# The Full Street-grid Solution

## Review of the I-81 Project April 2019 DEIS Community Grid plan, and presenting an alternative plan

Moneti Consulting

October 21, 2019

**Figure 1:** NYSDOT rendering: Franklin Square, looking southeast; a spaghetti junction remains, and it engulfs Webster’s Landing ever more; a high-speed junction for I-690 to BL-81 is not needed and undermines the street-grid concept—as does BL-81 itself.

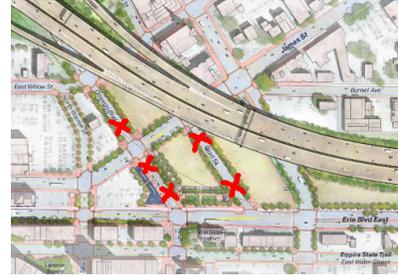
5. Franklin Square entrance (Webster’s Landing area) remains and is further engulfed in a slew of bridge and ramp roads, making it a pedestrian and development dead zone, and creates a blighted entrance to the Franklin Square neighborhood. (See Section: 4.4.6)

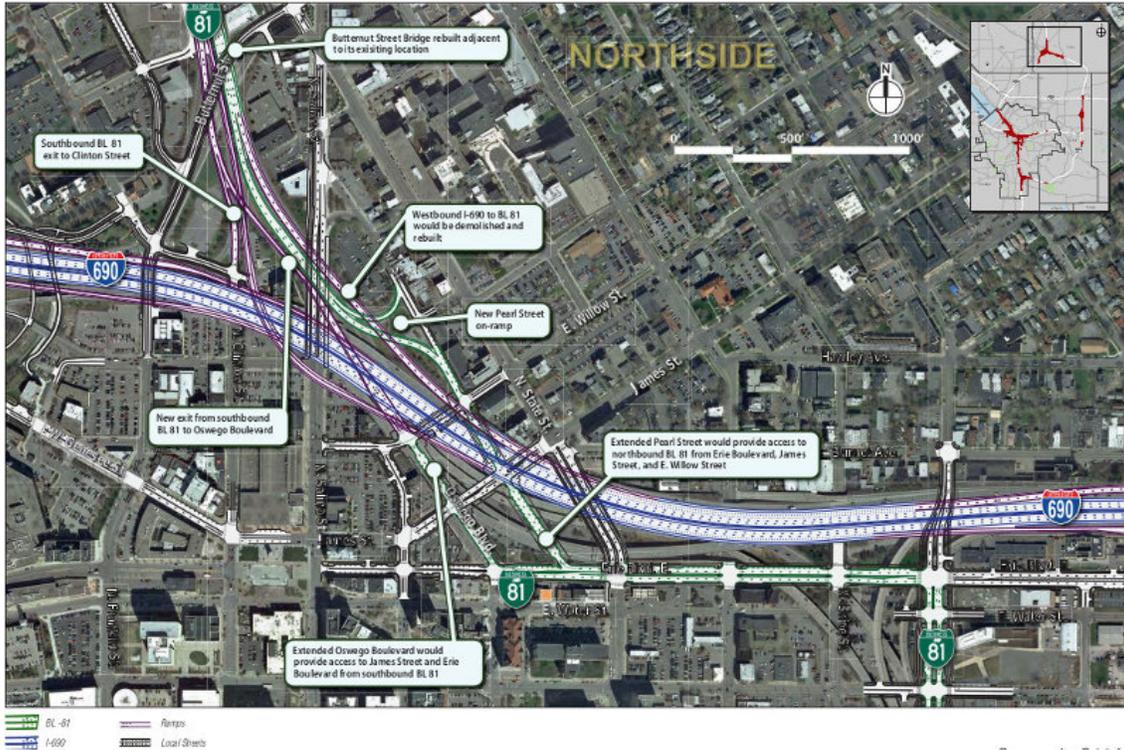
**Figure 14:** CG central plan: northern spaghetti junction remains; no North Side street-grid solution; no “land bridge” from North Side to Almond St; Erie Blvd will become congested, and “BL-81” Oswego Blvd and Pearl St ramps cut through the proposed “Canal District”, making the prospects of its successful development unrealistic.

**Figure 35:** I-81S junction at Almond St (NYSDOT); the planned high-speed diamond junction for Almond St / Glen Ave is not required or needed; a roundabout is more appropriate for city streets.

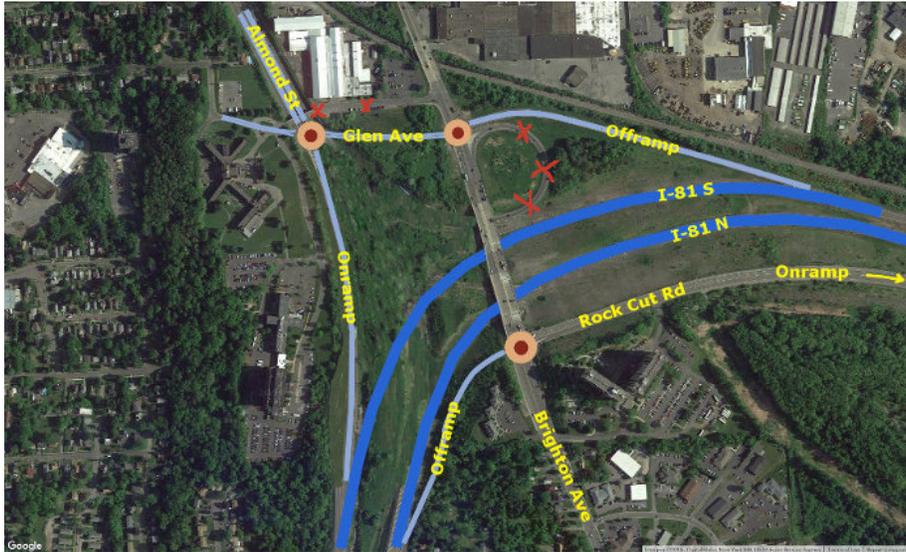
The CG plan re-aligns I-81 along current I-481. The I-81/I-481 ramps are transformed into the main highway road, and the existing highway road is transformed into ramps to Almond St. Fairly straightforward. Included is a diamond junction at Glen Ave, with Glen Ave bridging over Almond St. However, there is no requirement or need for a high-speed junction here since Almond St is no-longer a limited access highway. A roundabout at this junction would be more appropriate, consume less space, is less expensive to build, and would prepare traffic for slower city speeds.

**Figure 36:** I-81S junction at Almond St (Full Street-grid plan): A roundabout replaces the proposed diamond junction at Glen Ave.
